**ADDENDUM  
NO. 3**

**September 30, 2025**

**VALE FACILITY ADDITION/RENOVATIONS AND  
MAINTENANCE/IT FACILITY PROJECTS**

**Addendum Three (AD.03)** to the drawings and specifications prepared by Gibraltar Design for **Valparaiso Vale Facility Addition/Renovations and Maintenance/It Facility and Related Work** for Valparaiso Community Schools, Valparaiso, Indiana.

**8 RAMP EXPANSION B TO C**  
A-411 3/4" = 1'-0"

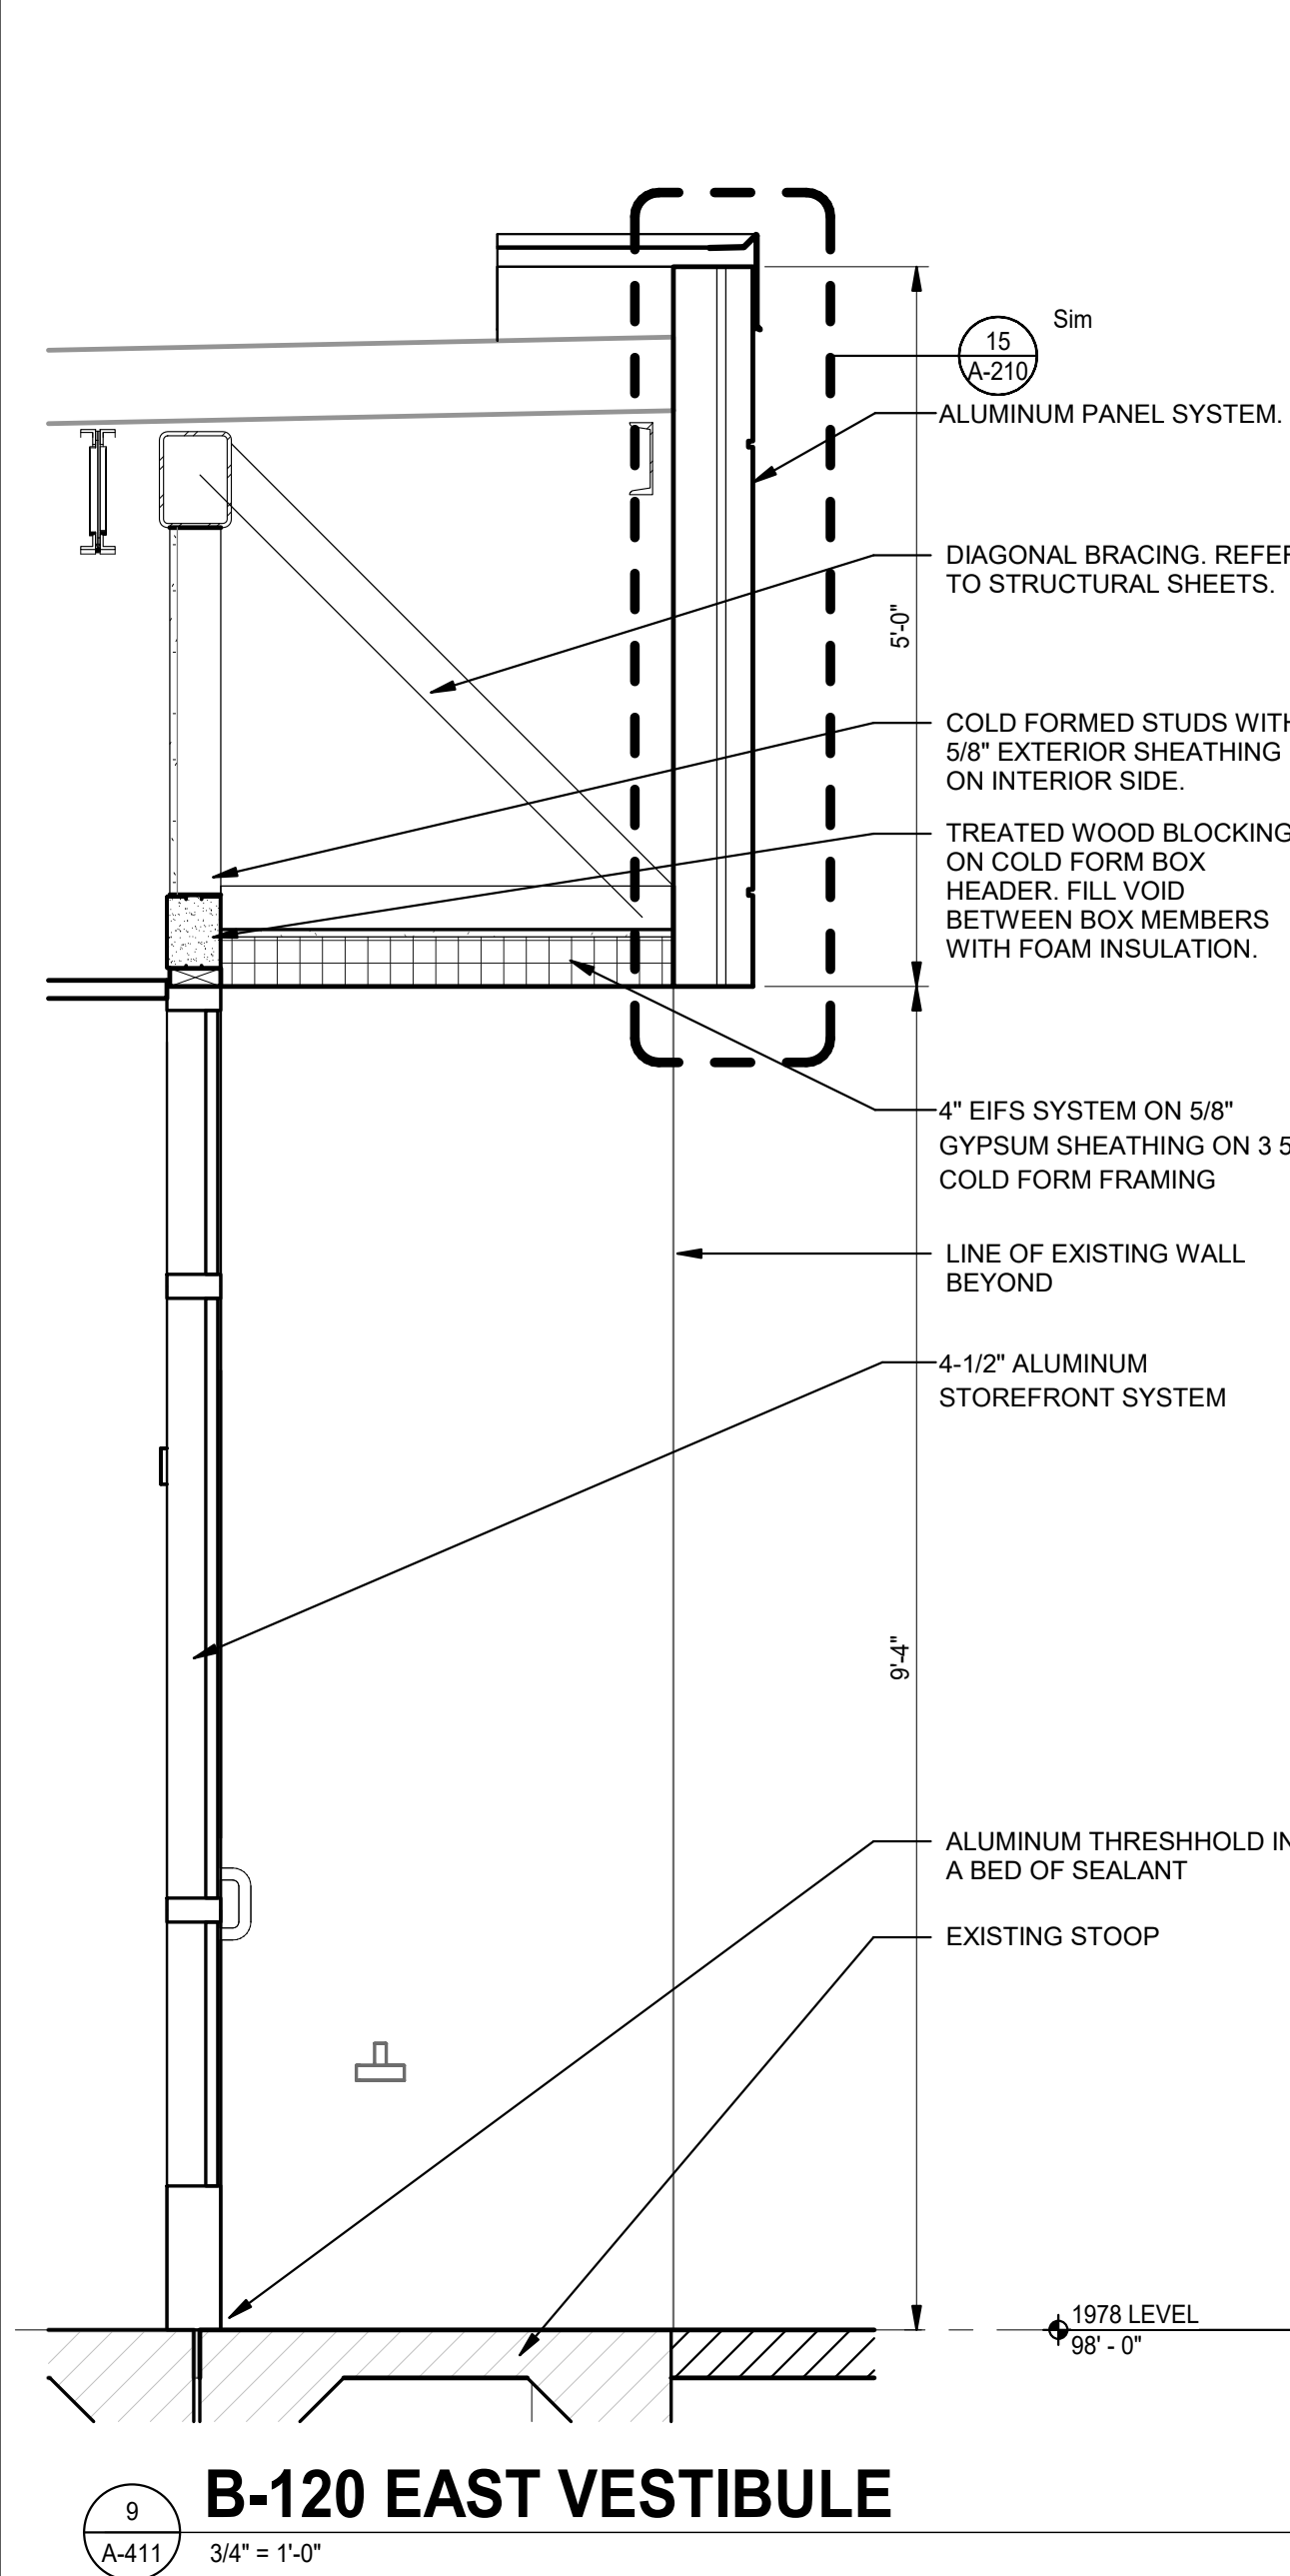
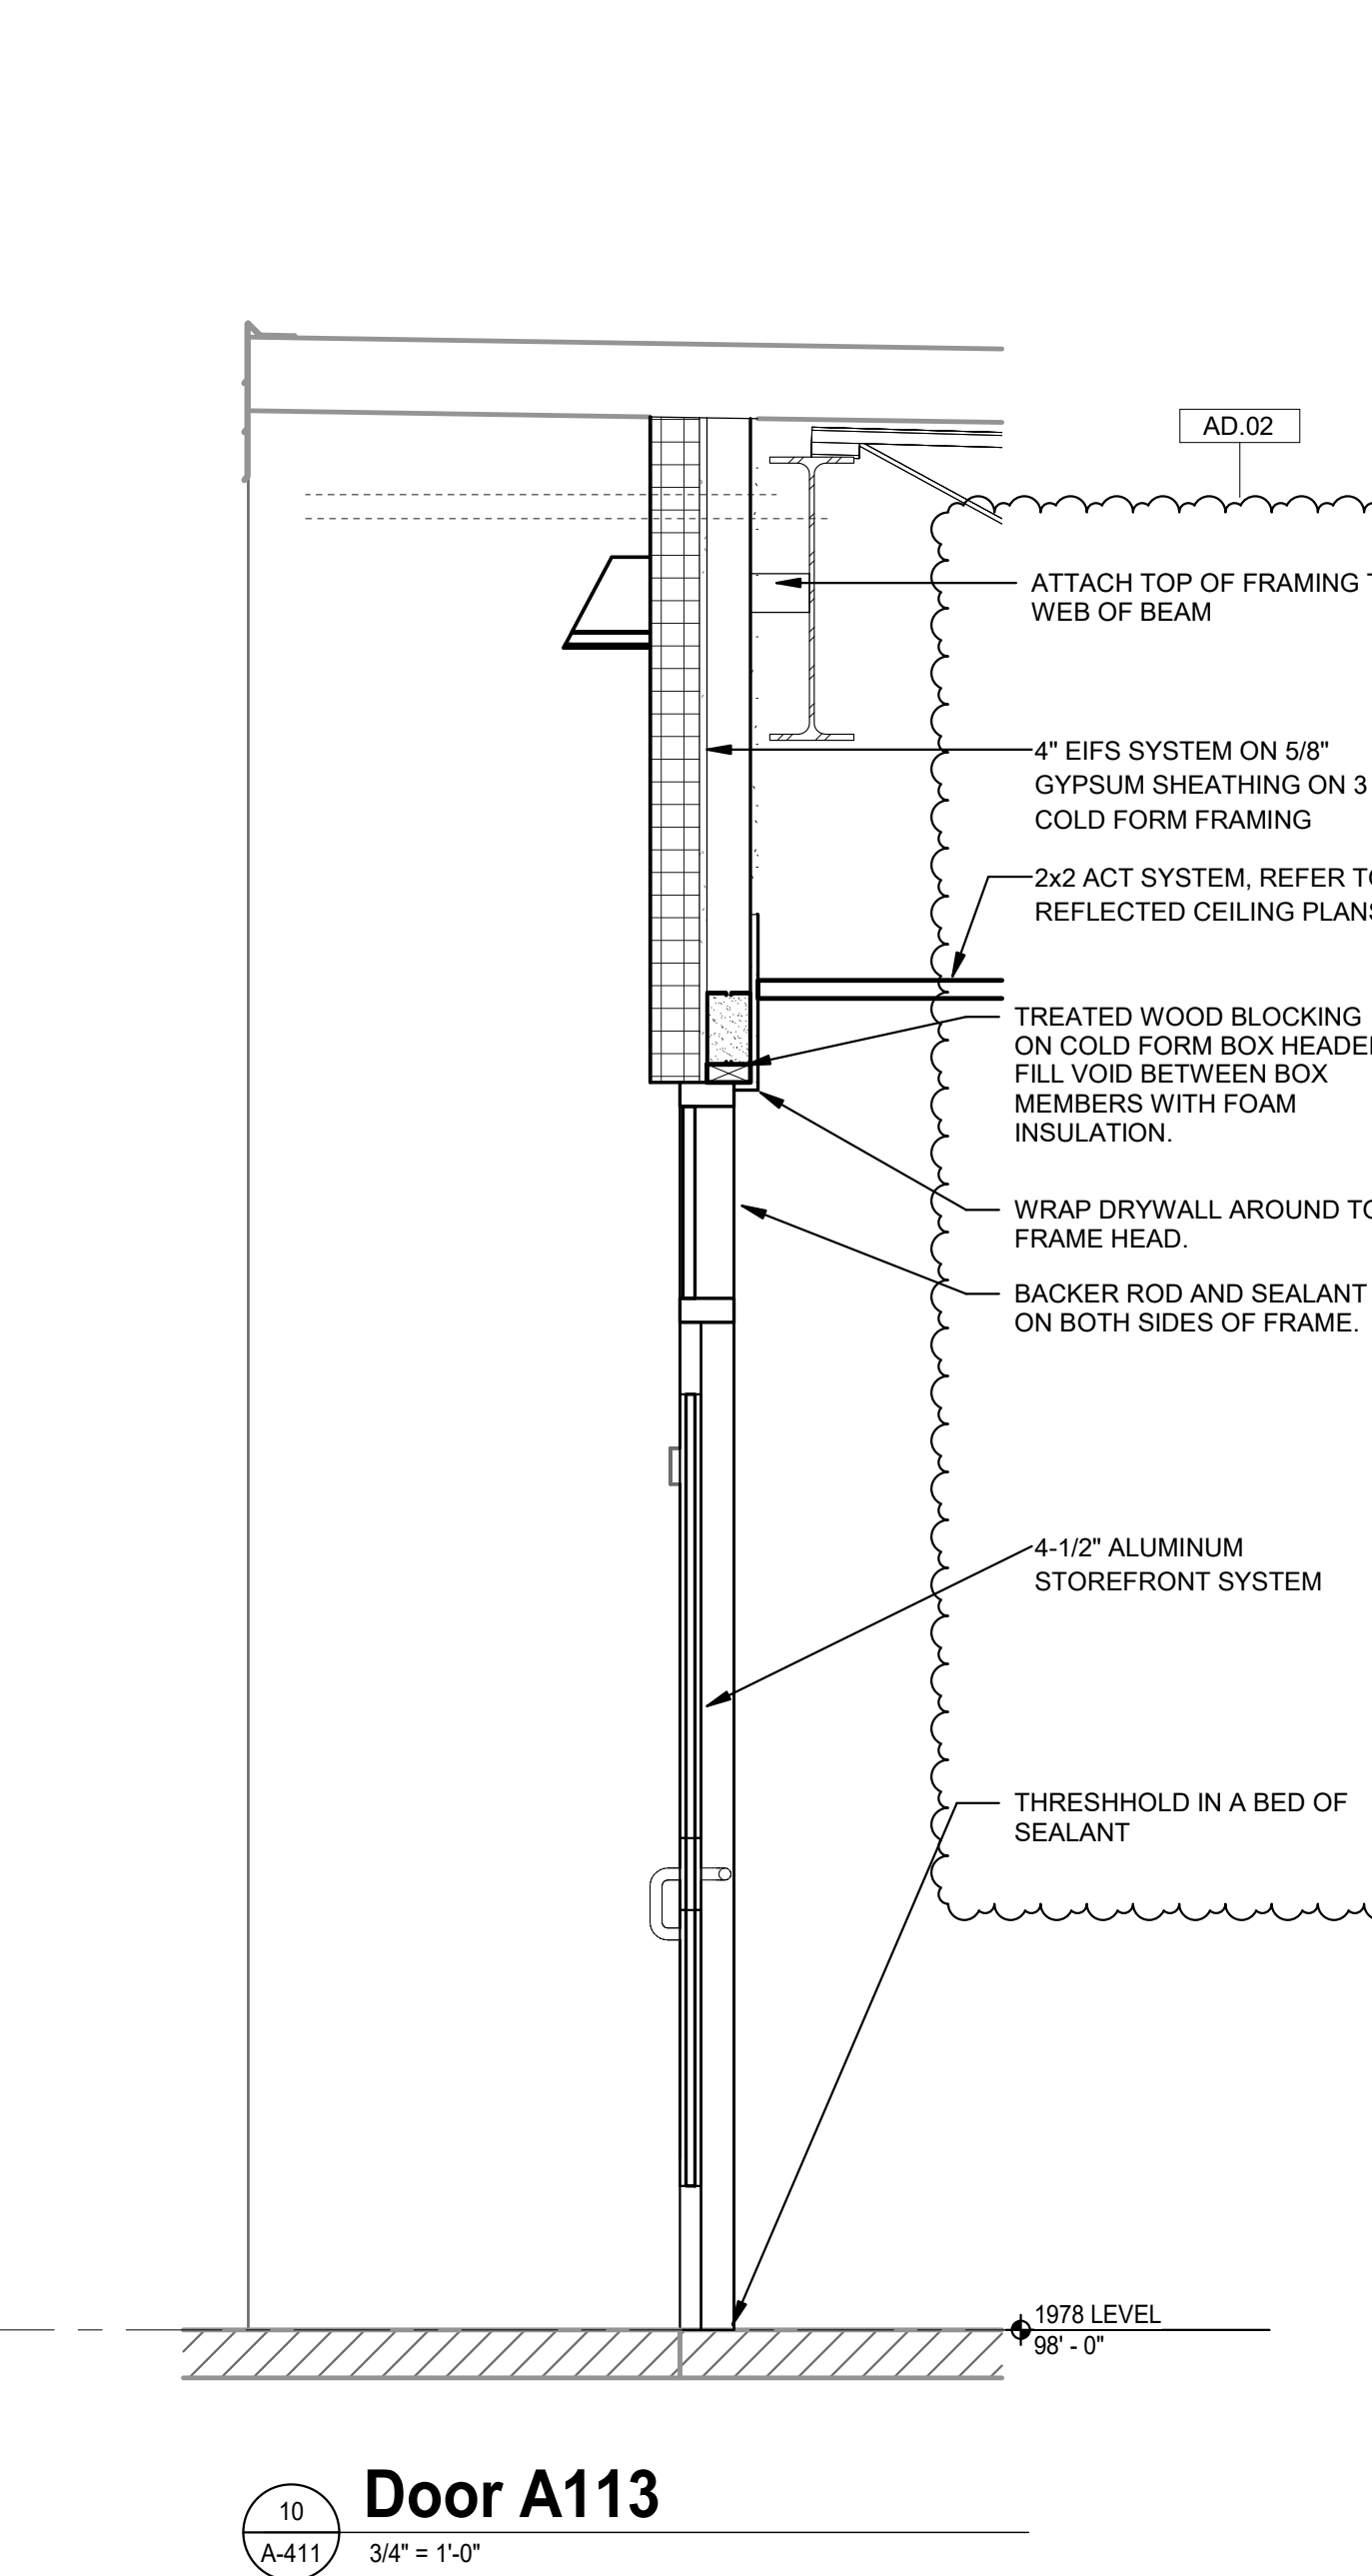
- A. Refer to revised, full-size drawing, included in this Addendum, for revisions.
  - 1. Added / Clarified expansion joints at slab to wall conditions.
  - 2. Clouded bottom of new exterior walls to refer to detail 1/A-410.
